# UNITED STATES PATENT AND TRADEMARK OFFICE

APPLICATION NO.	FILING DATE	FIRST NAMED INVENTOR	ATTORNEY DOCKET NO.	CONFIRMATION NO.
10/693,195	10/24/2003	Randall R. Geib	0241-P03282US0	2326
110 7590 12/10/2008 DANN, DORFMAN, HERRELL & SKILLMAN 1601 MARKET STREET SUITE 2400 PHILADELPHIA, PA 19103-2307				
EXAMINER GARCIA, ERNESTO				
ART UNIT		PAPER NUMBER		
3679				
MAIL DATE		DELIVERY MODE		
12/10/2008		PAPER

### Office Action Summary

### **DETAILED ACTION**

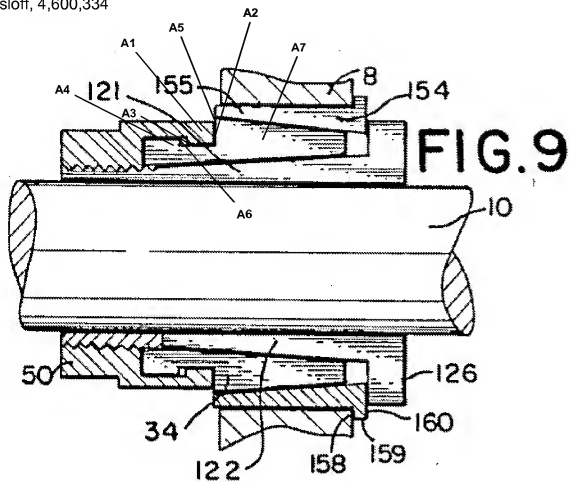
Regarding claim 24, Soussloff discloses, in Figure 9, a device comprising a nut **30**, an outer sleeve **34**, and an inner sleeve **120**. The nut **50** has a threaded portion **51** and a first connector **A1** (see marked-up attachment). The first connector **A1** has a first engagement surface **A2** and a second engagement surface **A3**. The outer sleeve **34** comprises a tapered internal surface **32** and a second connector **A4**. The second

connector **56** is connected with the first connector **A1**. The second connector **A4** has a first engagement surface **A5** and a second engagement surface **A6**. The inner sleeve **120** comprises a tapered external surface **25**, an interior bore **A2**, and a threaded portion **123**. The tapered external surface **25** corresponding in angle of taper to the tapered internal surface **32** of the outer sleeve **34**. The threaded portion **123** is remote from a forward end of the inner sleeve **120** and cooperable with the threaded portion **51** of the nut **30**.

Regarding claim 27, as best understood, the first connector **A1** is a flange and the second connector is a groove (note that features **A5** and **A6** make a groove).

FIG. 11

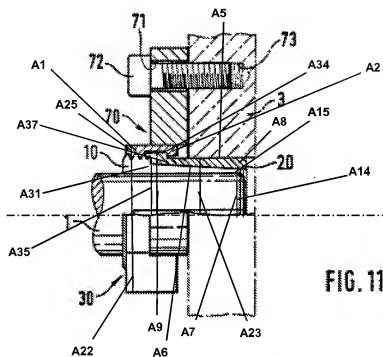
Regarding claim 9, Muellenberg discloses, in Figure 11, a device, comprising a one-piece inner sleeve **10**, a nut **30**, and an outer sleeve **20**. The inner sleeve **10** has a forward end **A15** (see marked-up attachment) and a rearward end **A31**. The inner sleeve **10** comprises a threaded portion **A1** (similar to **8** in Figure 1), a frustoconical external surface **6** (see Figure 1 as guide) and an internal bore **5** (see Figure 1 as guide). The frustoconical external surface **6** has a major diameter **A35** adjacent the threaded portion **8** (see Figure 1 as guide) and a minor diameter **A14** spaced from the major diameter **A35** toward the forward end **A15** of the inner sleeve **10**. The nut **30** has a threaded portion **15** at one end **A25** and an engagement element **17** spaced from the one end **A25**. The outer sleeve **20** has a forward end **A8** and a rearward end **A37**. The outer sleeve **20** comprises a frustoconical interior surface **12**, an exterior surface **12** and

a circumferential interlock **13**. The frustoconical interior surface **12** correspond in angle of taper to the frustoconical external surface **6** of the inner sleeve **10**. The frustoconical interior surface **12** has a major diameter **A9** and a minor diameter **A7**. The major diameter **A9** is adjacent the rearward end **A31** and the minor diameter **A7** is adjacent the forward end **A8**. The exterior surface **12** corresponds to the bore **4** of the machine element **3**. The circumferential interlock **13** engages the engagement element **17** of the nut **30**.

Regarding claim 1, Muellenberg discloses, in Figure 11, a device comprising a nut **30**, an outer sleeve **20**, and an inner sleeve **10**. The nut **30** has a threaded portion **A1** (see marked-up attachment which is similar to 15 in Figure 1) and a first connector **A2**. The first connector **A2** has a forward surface **A3** and a rearward surface **A4** spaced from the forward surface **A3**. The rearward surface **A4** is spaced from the threaded portion **A1**. The outer sleeve **20** comprises an external surface **A5** (similar to 12 in Figure 1), a tapered internal surface **A6** (similar to 11 in Figure 1), at least one axial slot (col. 4, lines 62-64) and a second connector **A7**. The second connector **A7** comprises a rearward surface **A29** cooperable with the rearward surface of the first connector **A2**. The tapered internal surface **11** has a minor diameter **A7** adjacent a

forward end **A8** of the outer sleeve **20** and a major diameter **A9** spaced rearwardly from the forward end **A8**. The axial slot extends longitudinally along the outer sleeve **20**. The second connector **A7** is connected with the first connector **A2**. The inner sleeve **10** comprises a tapered external surface **6** (see Figure 1 as guide) corresponding in angle of taper to the tapered internal surface **11** of the outer sleeve **20**. The inner sleeve **10** has a minor diameter **A14** adjacent a forward end **A15** of the inner sleeve **10** and a major diameter **A35** spaced rearwardly from the forward end **A15** of the inner sleeve **10**. The inner sleeve **10** has a threaded portion **8** (see Figure 1 as guide) remote from the forward end **A15** of the inner sleeve **10** and cooperates with the thread portion **15** of the nut **30**.

**FIG. 7**

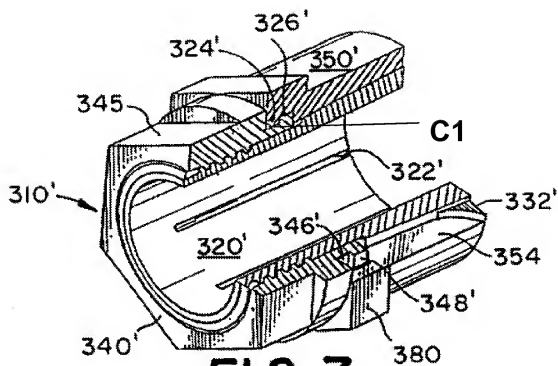
Regarding claim 3, Muellenberg, as modified, discloses the outer sleeve **20** being sufficiently resilient such that the outer sleeve **20** contracts. However, Muellenberg fails to disclose the first connector **A2** comprises a circumferential groove and the second connector **A7** comprises a flange **13** extending radially inwardly. Instead, Muellenberg teaches the reverse configuration. Geib '297 teaches, in Figure 7, a first connector comprising a circumferential groove **C1** (see marked-up attachment) on

a nut 340' and a second connector 324' comprising a flange 324' on an outer sleeve 350' and extending radially inwardly to place the outer sleeve over the nut in reverse rather than having the nut over the outer sleeve (col. 6, lines 58 - col. 7, line 9).
